OHIO DEPARTMENT OF TRANSPORTATION
CENTRAL OFFICE, 1980 W. BROAD ST., COLUMBUS, OHIO 43216-0899

Re: 2009 Second Quarter Revisions

Summary of Revisions to the July 2007 ODOT BDM

FIGURE 303.5.1-1

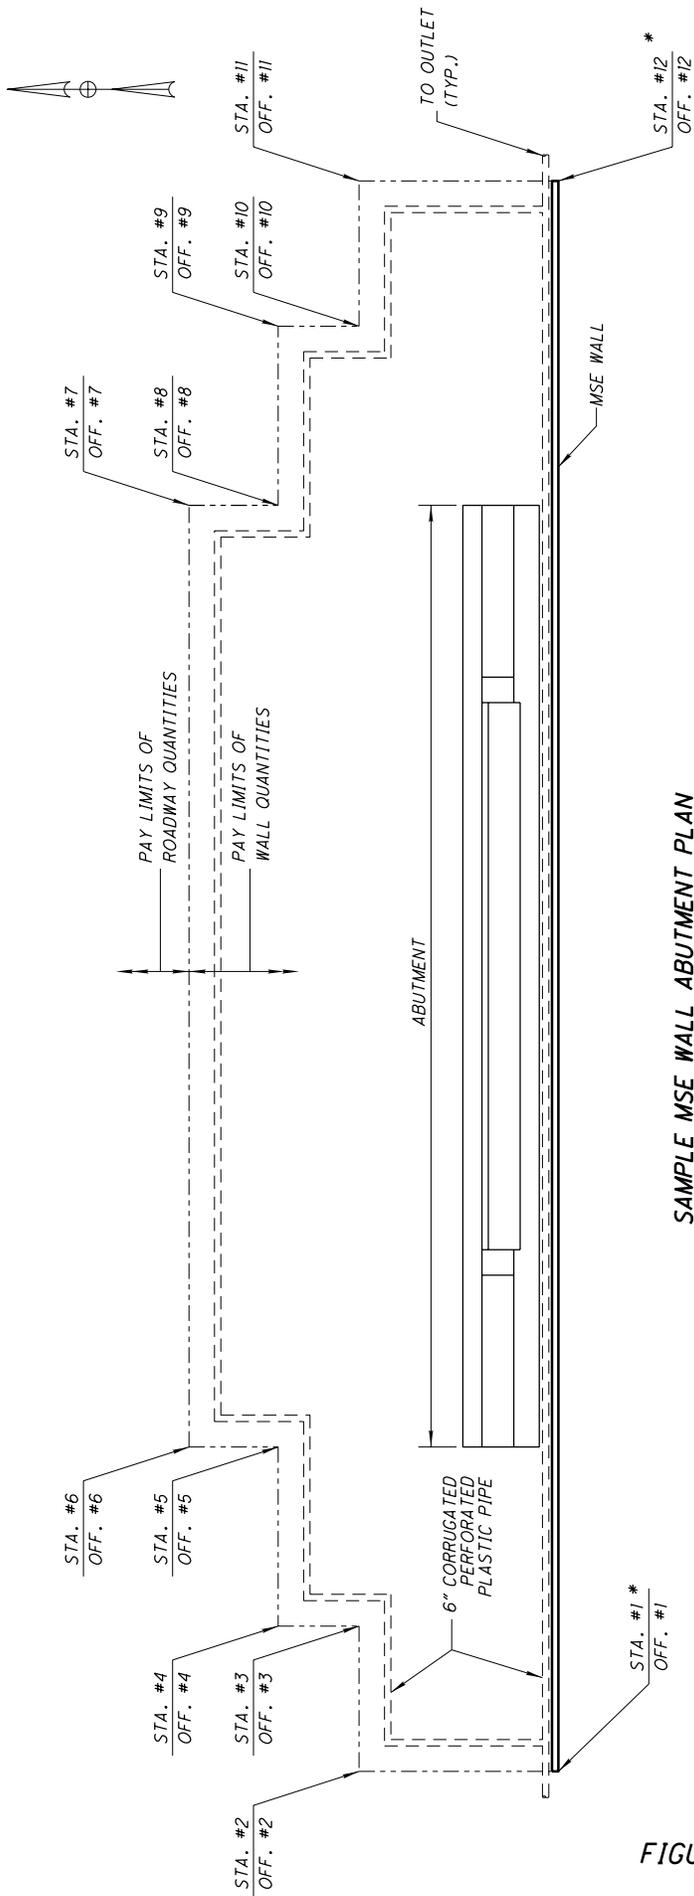
208.1	2-36 through 2-36.2	This revision provides clarification for when to include a pay item for “Cofferdams, Cribs and Sheeting”.
303.5.1	3-70 through 3-71	The revisions in this section reflect changes to the MSE wall figures provided in BDM Section 303.5.1.
Figure 303.5.1-1		The “Pay Limits of Wall Quantities” have been modified to reflect a more realistic soil reinforcement layout. These limits also reflect the changes made to Figures 303.5.1-2 and 303.5.1-3.
Figure 303.5.1-2		The volume of select granular material and Type B granular material has been reduced by eliminating the 1:1 sloping interface with the Item 203 embankment.
Figure 303.5.1-3		The volume of select granular material and Type B granular material has been reduced by eliminating the 1:1 sloping interface with the Item 203 embankment.
Figure 303.5.1-5		The volume of select granular material has been reduced by eliminating the 1:1 sloping interface with the Item 203 embankment.

FIGURE 303.5.1-6

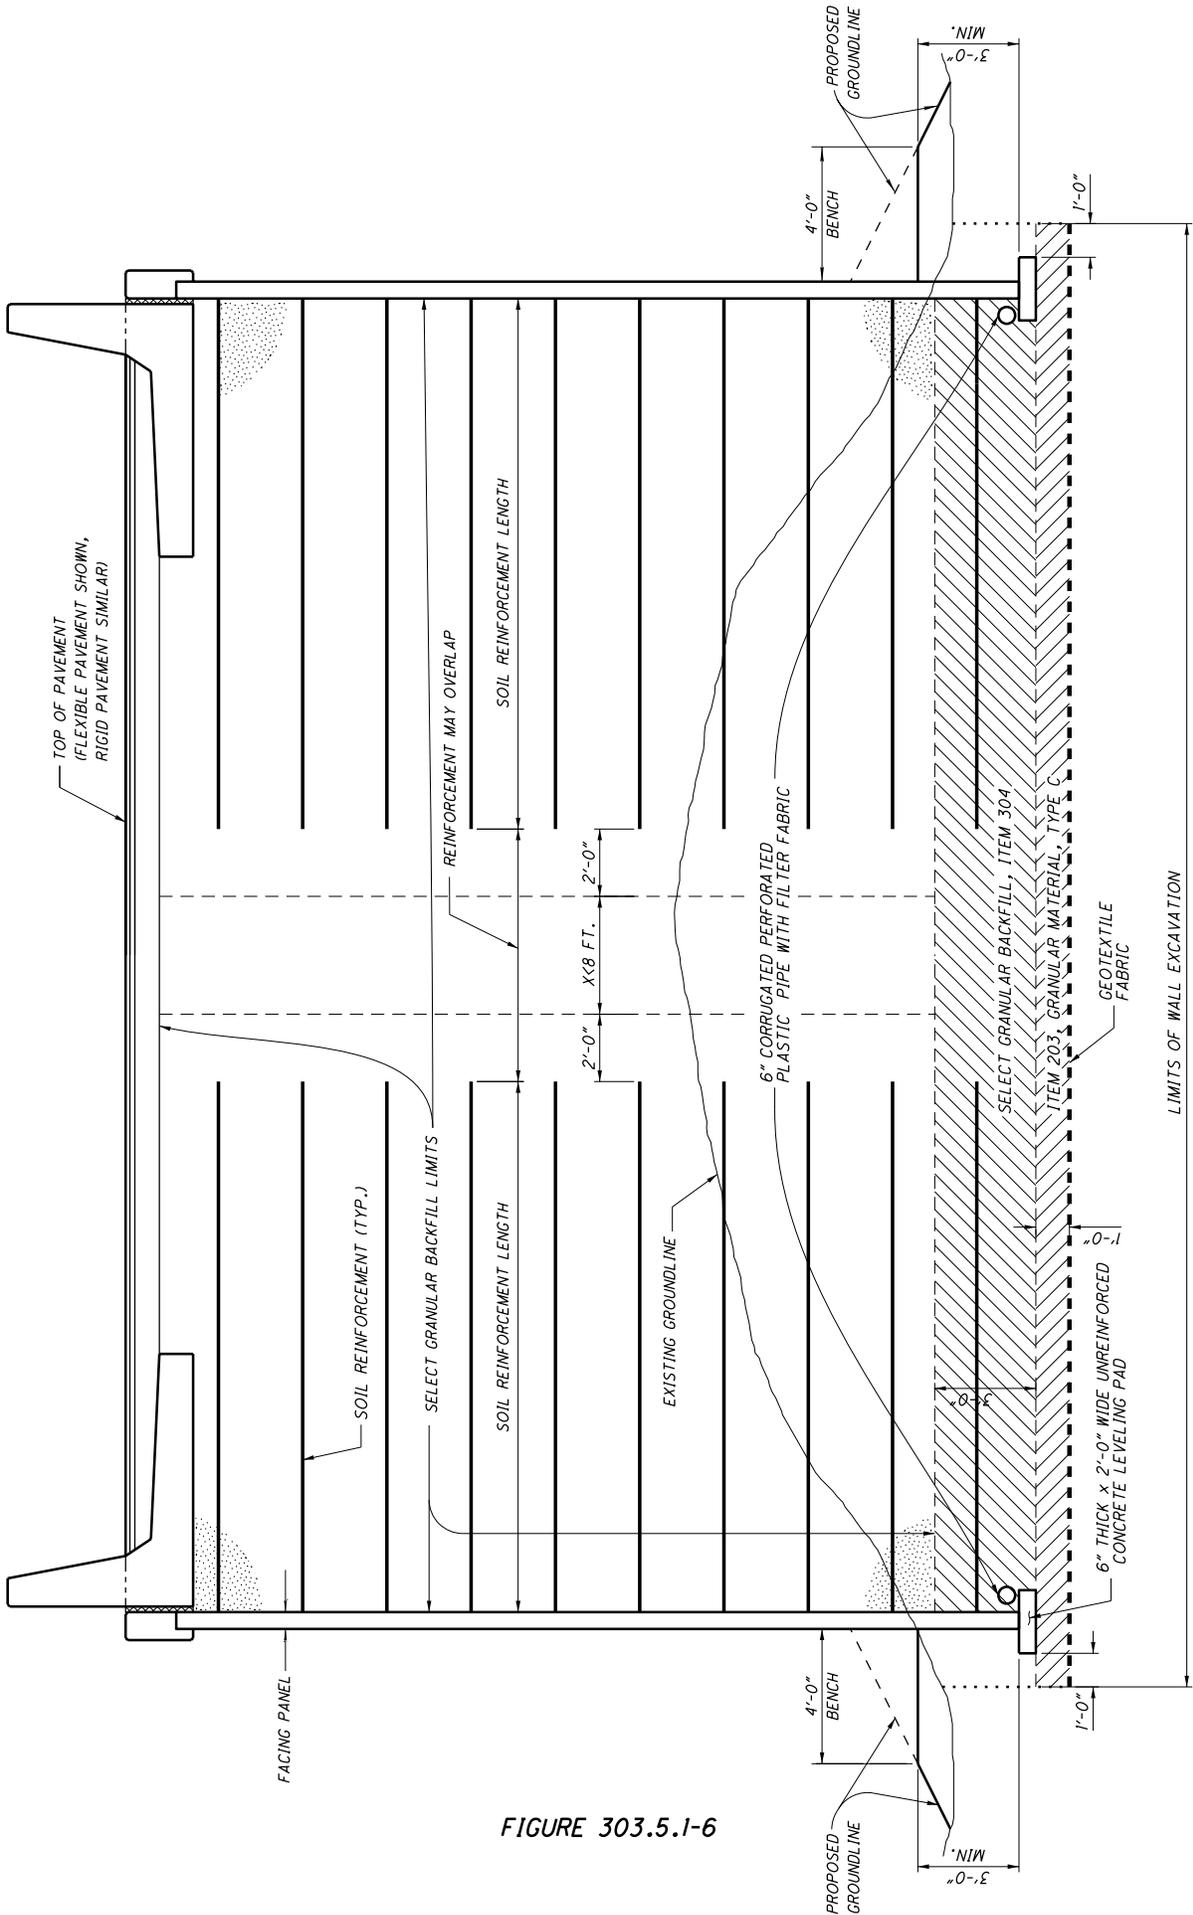
Figure 303.5.1-6		This new figure illustrates a wall layout for back-to-back MSE walls with 12-ft or less distance between free ends of the soil reinforcements.
Figure 303.5.1-7		This new figure illustrates a wall layout for back-to-back MSE walls with greater than 12-ft between free ends of the soil reinforcements.
